Project No: 1854
Sketch No: SK001.0
Date: 14 Sept 21
Author: ACB

Home Arches
Fire Strategy Sketch; Fire resisting separations

Home ARCHES
Fire Strategy Sketch;
Means of escape (MoE)

Home Arches
Fire Strategy Sketch;
Parts B2, B4 & B5

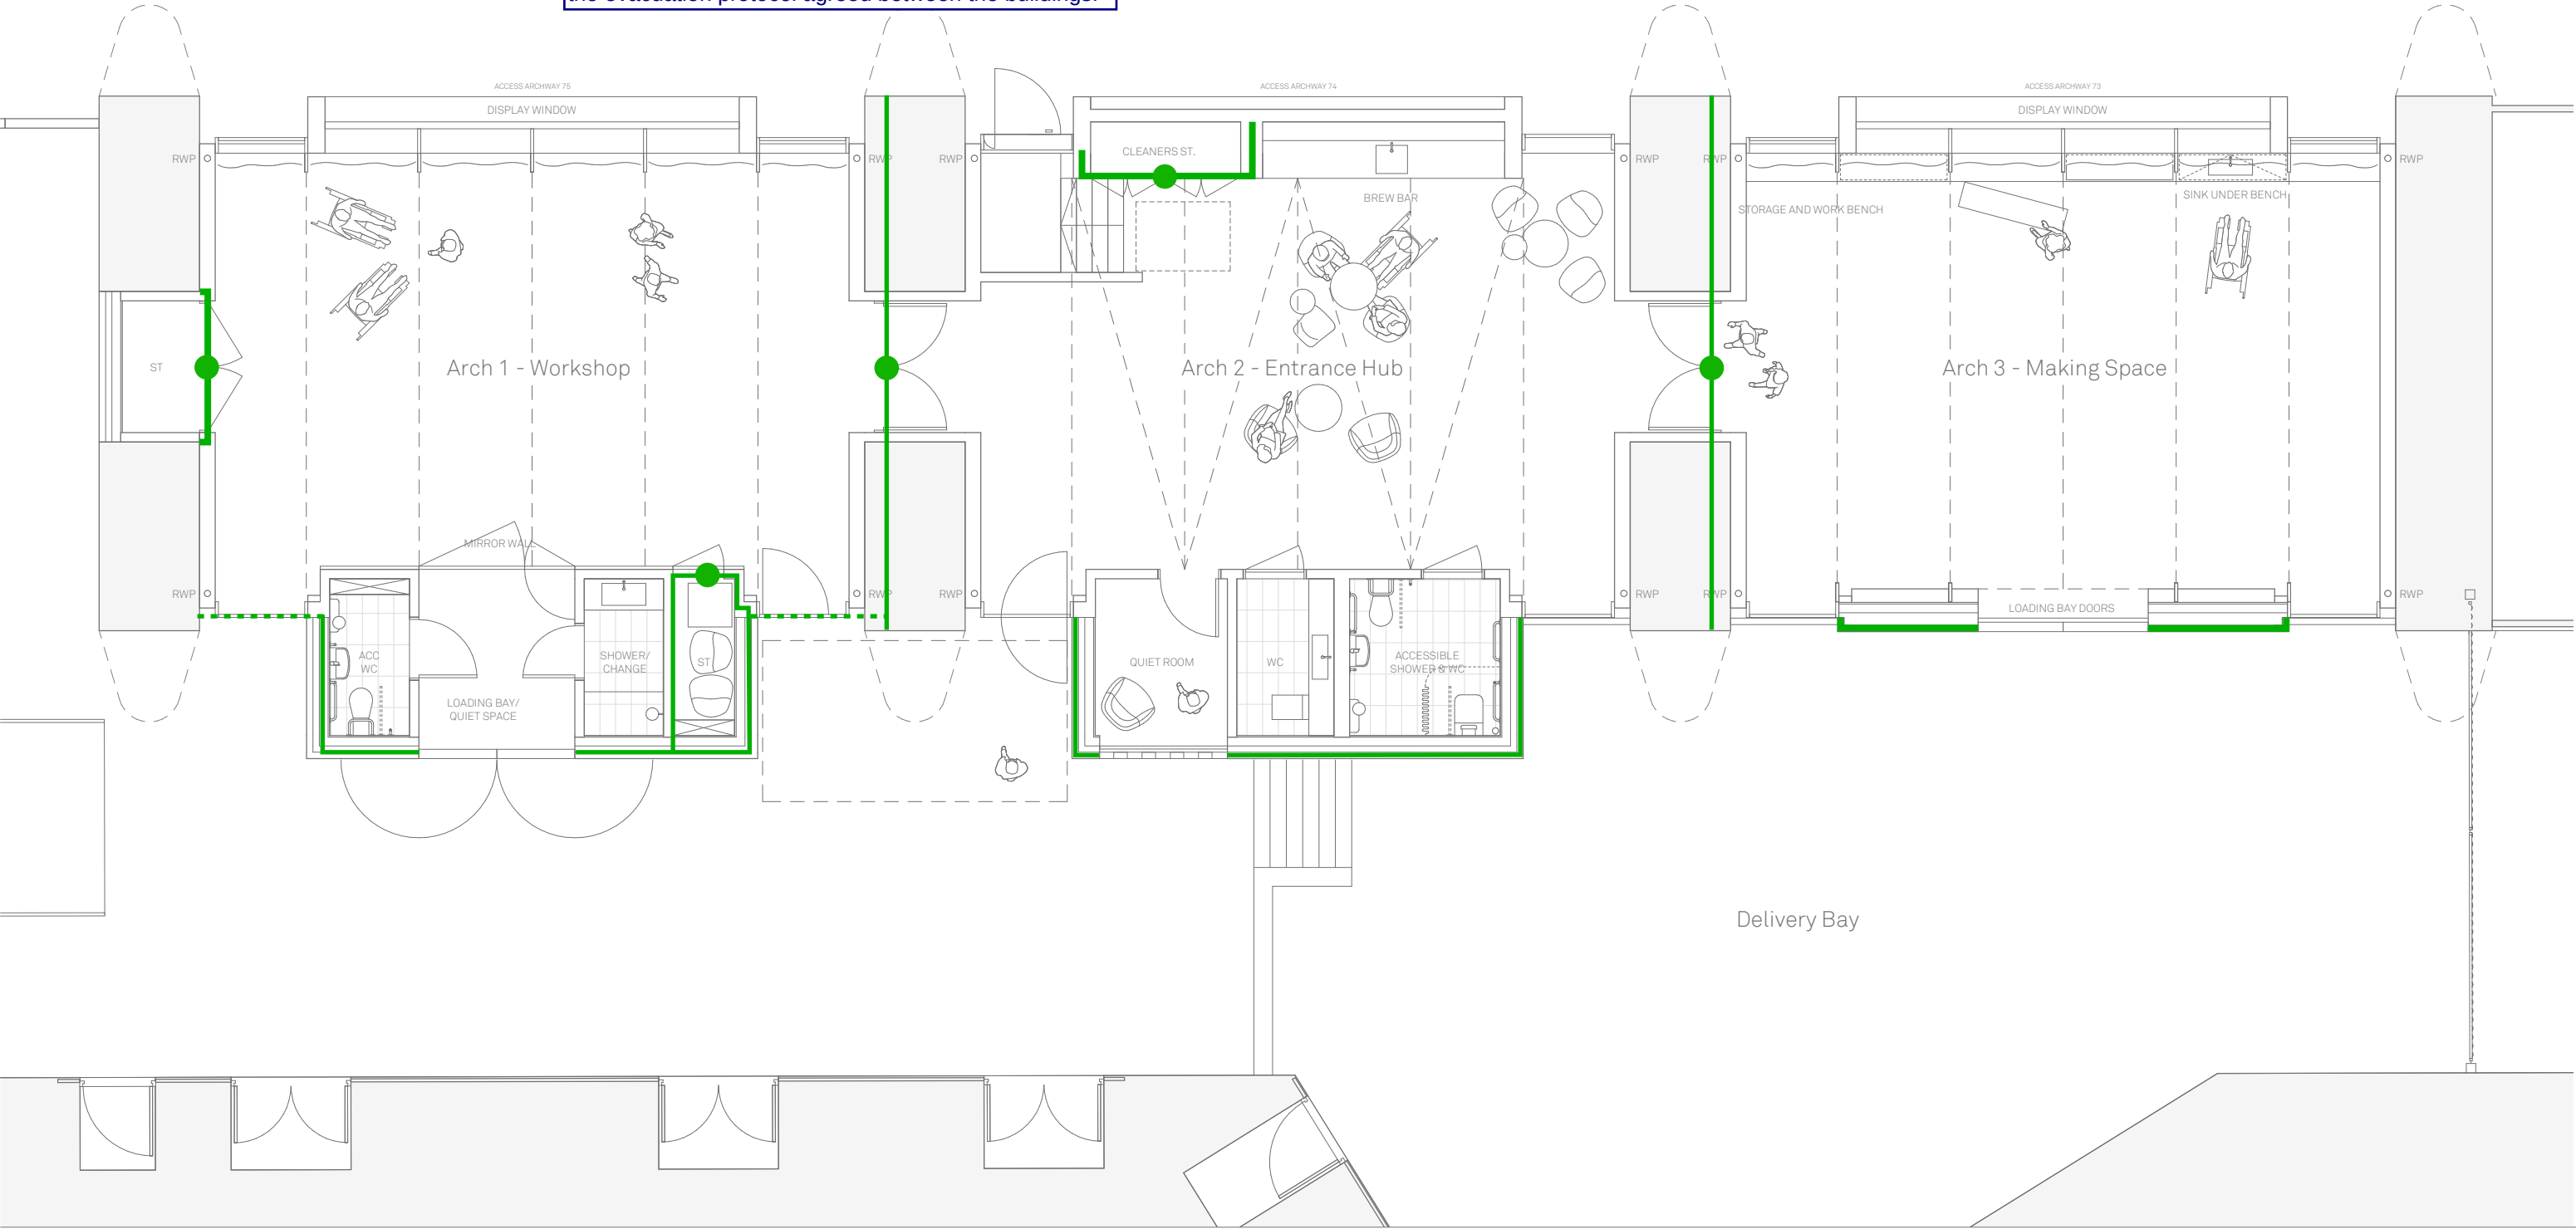
A minimum fire resistance period of 30 minutes applies throughout. The structural / loadbearing fire resistance of the arch is likely to require a longer period subject to rail operator confirmation.

The south elevation requires a portion of fire resistance to mitigate the potential for fire spread to HOME. Initial review indicates that the proposed glazing may be unprotected for this purpose.

Any external wall within 1.8m of the Arches external escape routes must also be fire resisting.

The illustrated fire resistance does not confirm protection of HOME occupants evacuating in the event of a fire in the Arches, which may require fire resistance to further portions of the south elevation, depending on the evacuation protocol agreed between the buildings.

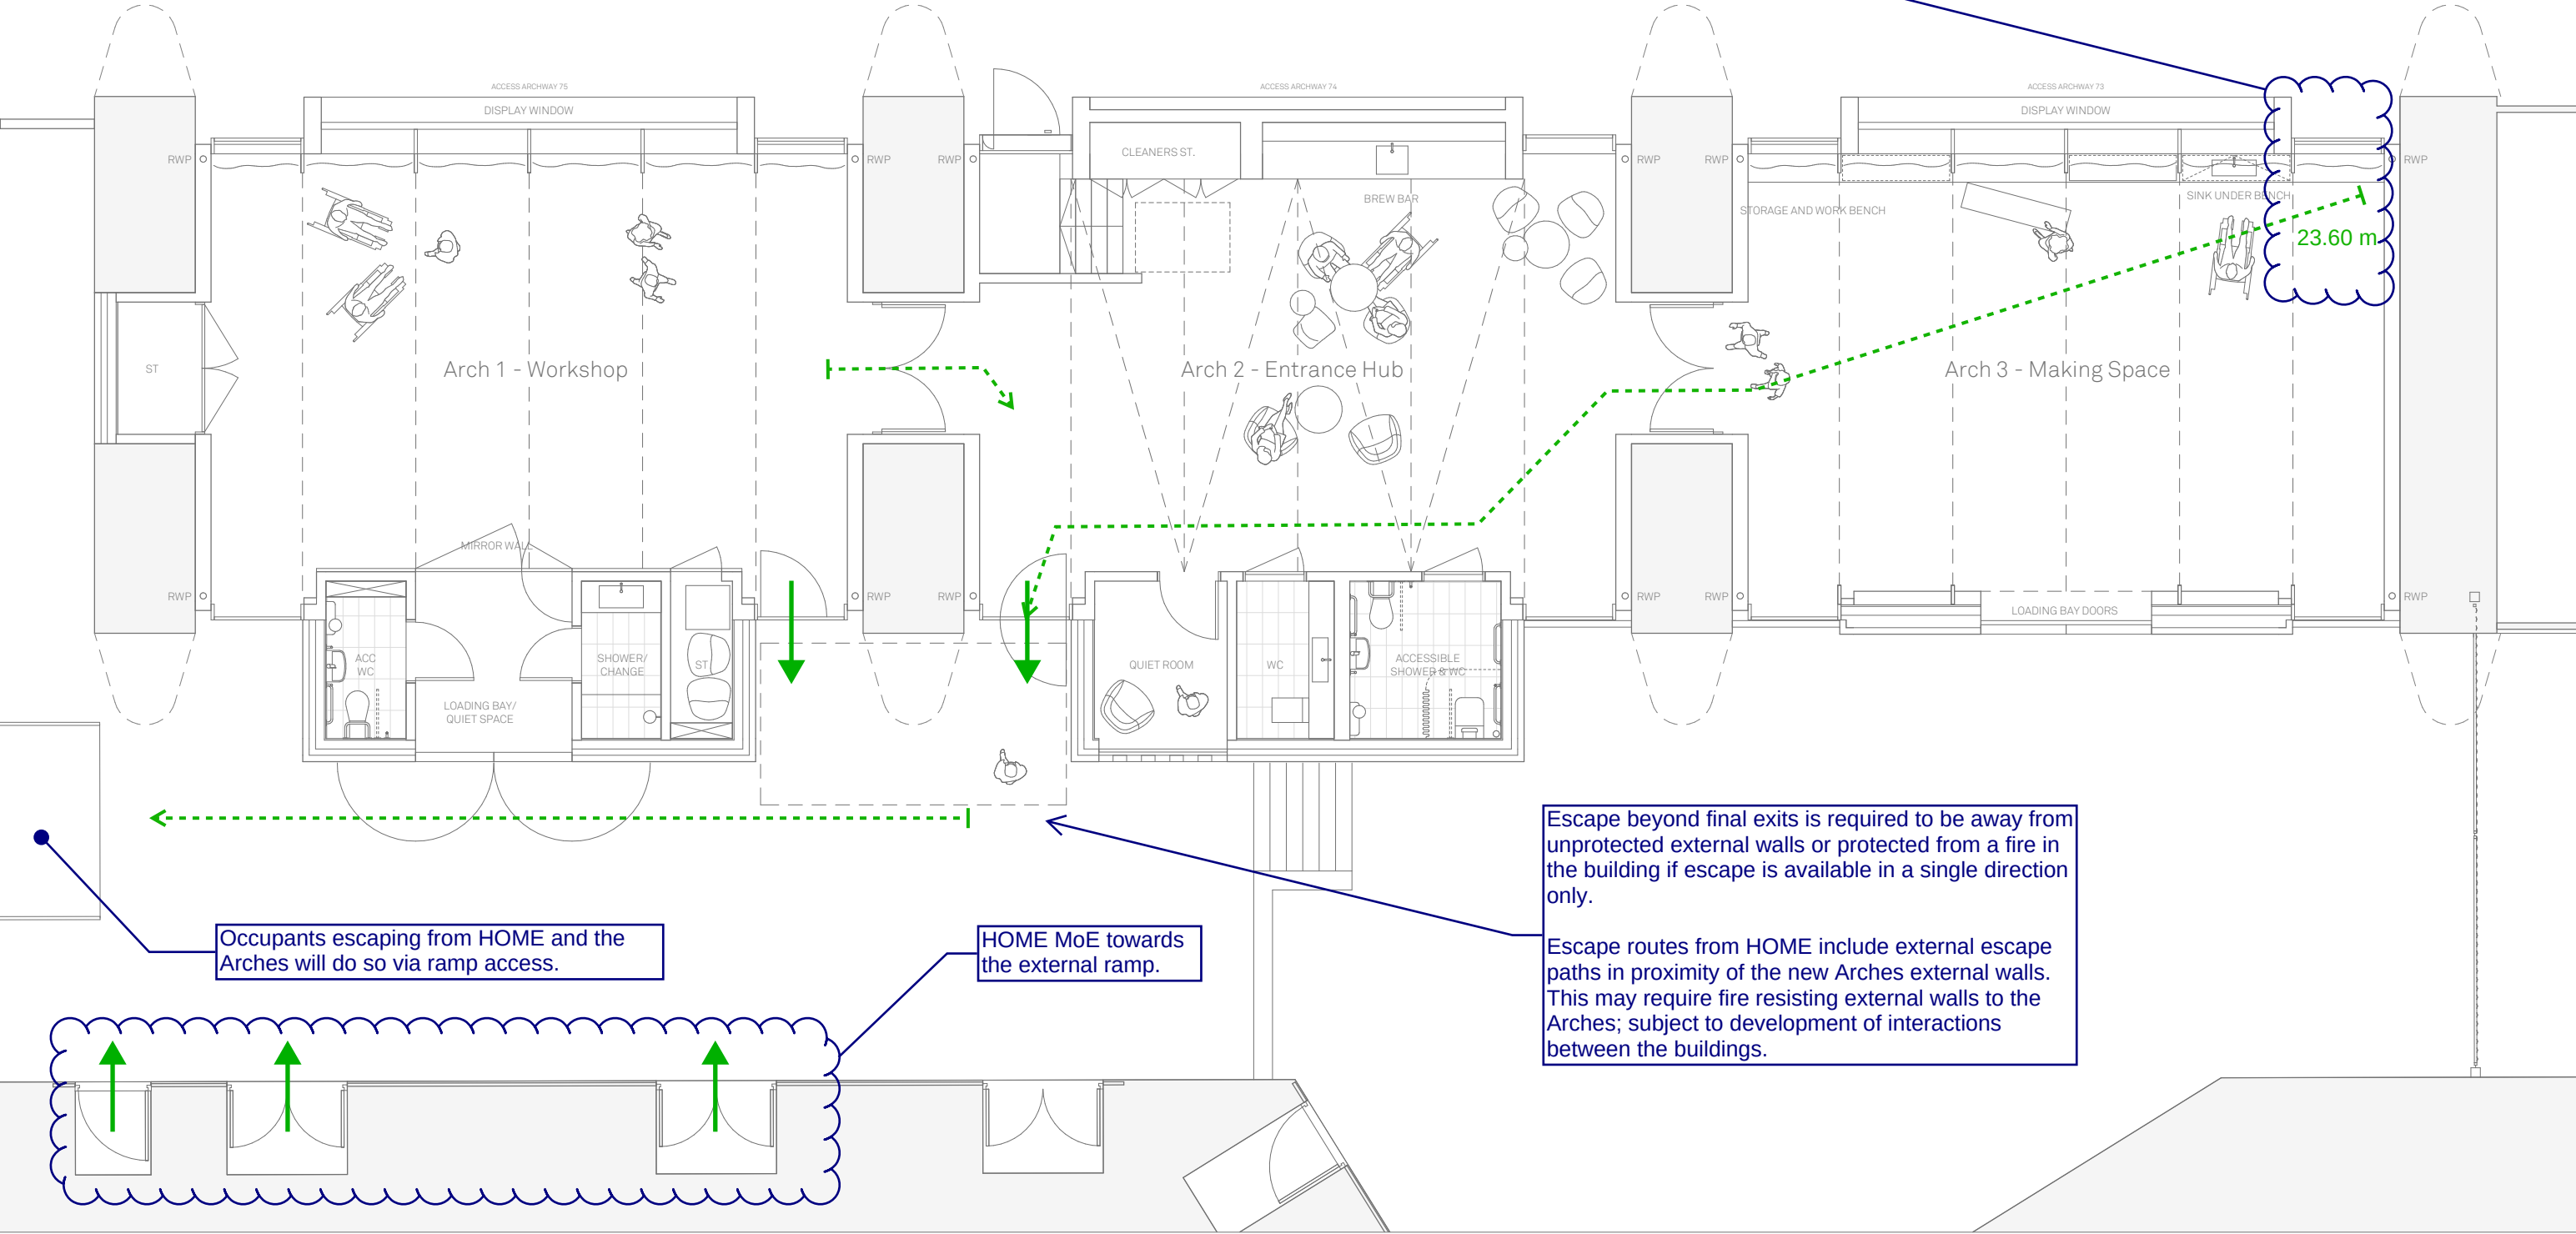
The maximum single direction travel distance recommended in BS 9999 is identified on plan (23.6m). Therefore, the layout is very sensitive to fit-out and use.

Should flexibility in use be important or should a number of people require assistance to escape, or take a significant time to reach an exit, external exits from each space may be preferred based on operational risk assessment and management considerations.

Any stepped egress would require a protected refuge space and staff response to assist escape. Each compartment would be an appropriate refuge from a fire in another compartment.

Occupants escaping from HOME and the Arches will do so via ramp access.

HOME MoE towards the external ramp.

Escape beyond final exits is required to be away from unprotected external walls or protected from a fire in the building if escape is available in a single direction only.

Escape routes from HOME include external escape paths in proximity of the new Arches external walls. This may require fire resisting external walls to the Arches; subject to development of interactions between the buildings.

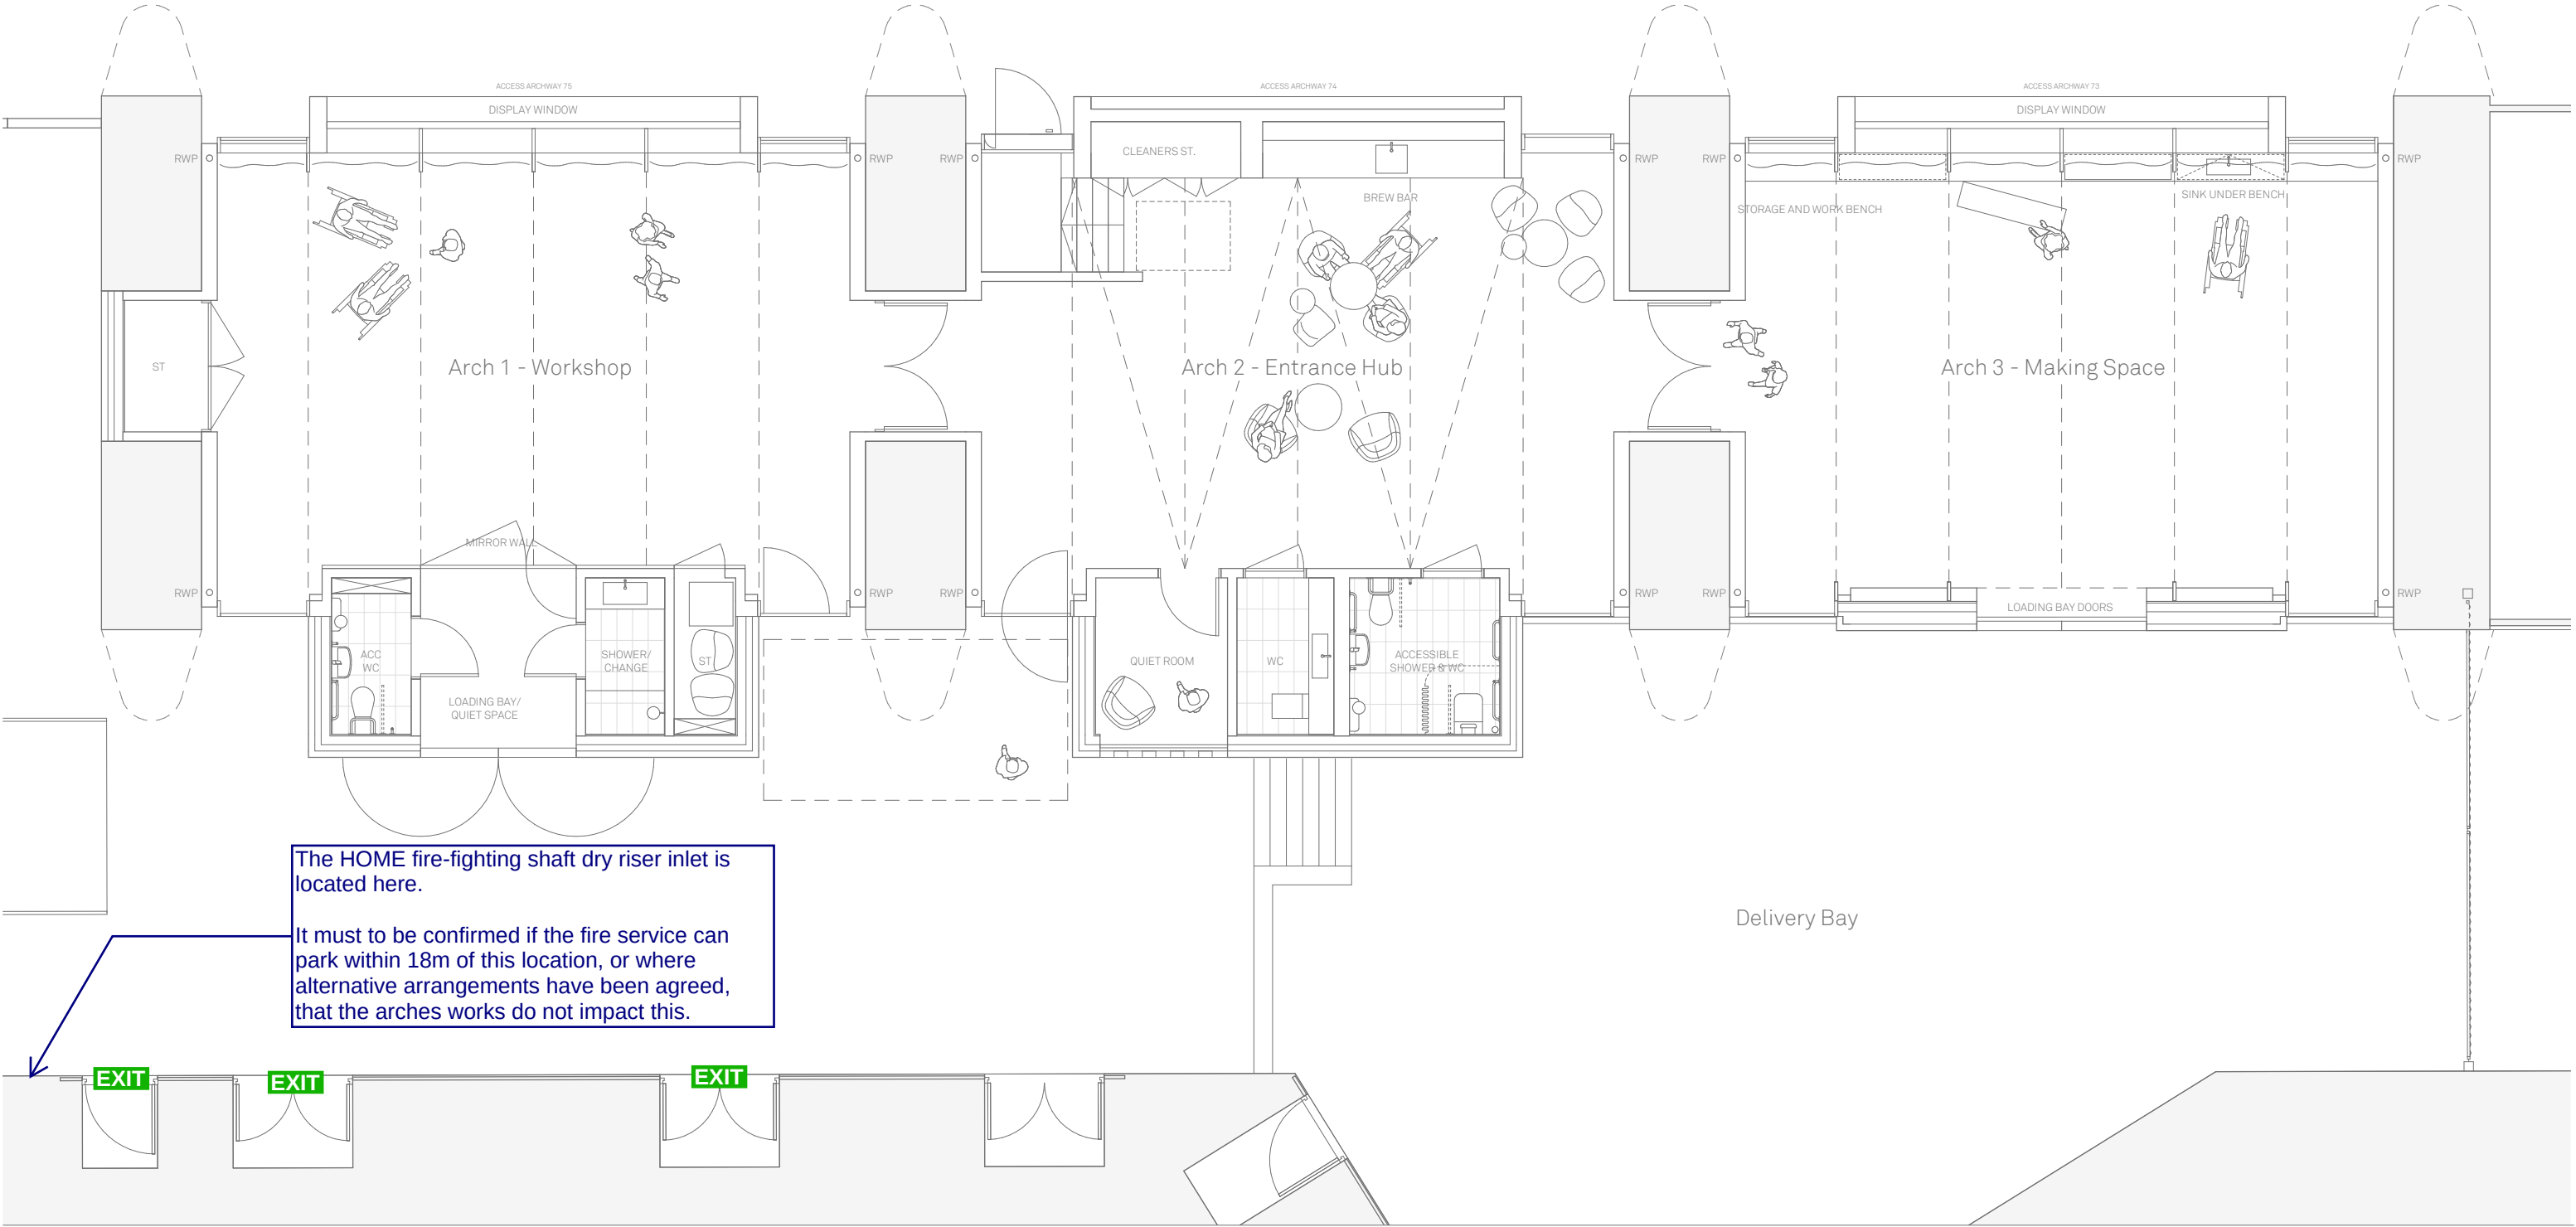
From the HOME fire strategy, it is understood that the relevant boundary is 1.8m from that building. Initial review indicates that the proposed glazing may be unprotected for the purpose of mitigating fire spread between the buildings. However, external wall fire resistance may also be required to protect MoE.

The HOME fire strategy suggests that the fire service access to the HOME fire main inlet is within 18m. From site information, the access path is unclear and should be confirmed. Based on existing hoarding it is understood that Arches 1-3 do not provide the HOME fire-fighter access route and therefore, no impact on existing arrangement has been identified.

The HOME fire-fighting shaft dry riser inlet is located here.

It must to be confirmed if the fire service can park within 18m of this location, or where alternative arrangements have been agreed, that the arches works do not impact this.
